Town of Surfside

Construction of Town of Surfside 96th Street Park

Addendum No. 3

Date Issued: 9/15/2022

SHEET: SW102

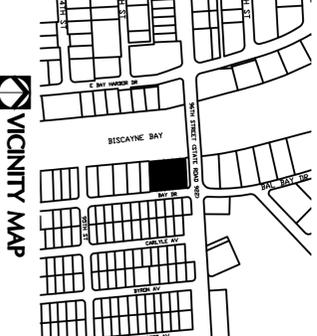
- 5. Please confirm the Total Count of proposed Turbidity Curtains for this project. The Marine Structural Plans show one (1) proposed Turbidity Curtain. The Stormwater Pollution Plans show three (3) proposed Turbidity Curtains. Please confirm these are all to be treated as separate Turbidity Curtains and that there is no overlap.**

There are 3 sets of turbidity curtains, to protect the channel and to protect the corals on the riprap. The 3 sets must be installed as shown on sheet SW-102, which has been revised to show the correct lengths.

SHEET: LH-01
 DESIGNER: BOBBI R. MILLER, LIC # LA0000993
 SEAL: _____
 DATE: _____

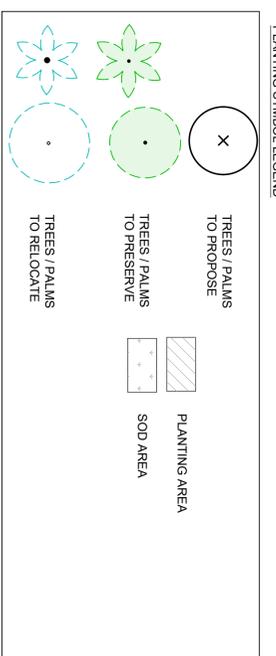
- 3. Please provide a Manufacturer, Specifications, and Vendor Representative Contact Information for the Engineered Wood Fiber (Sheet LH-01, Hardscape Schedule, Key #7).**

10. In the process of performing proprietary takeoffs of certain square footages/areas (primarily Hardscape), we have found that our internal square footages (areas) do not match those of the plans and Price Submittal Form. Please confirm if we are to provide pricing based off the exact square footages stipulated on the plans and Price Submittal Form or if we are to provide pricing using our own square footages based on our own takeoffs. Also, please confirm if we are to edit the square footages (areas) shown on the Price Submittal Form.

Fibar Engineered Wood Fiber
800-342-2721
ASTM F1292 / F2075 / F1951 Certified

Please see revised quantities on LH-01, which match revised Price Submittal Form, provided in pdf and excel. Some quantities have been changed to Lump Sum on the Price Submittal Form to provide more flexibility for bidders. All changes are in red text on plans and Price Submittal Form and clouded on the plan. Please provide pricing based on square footages provided and do not change any square footages on the Price Submittal Form.
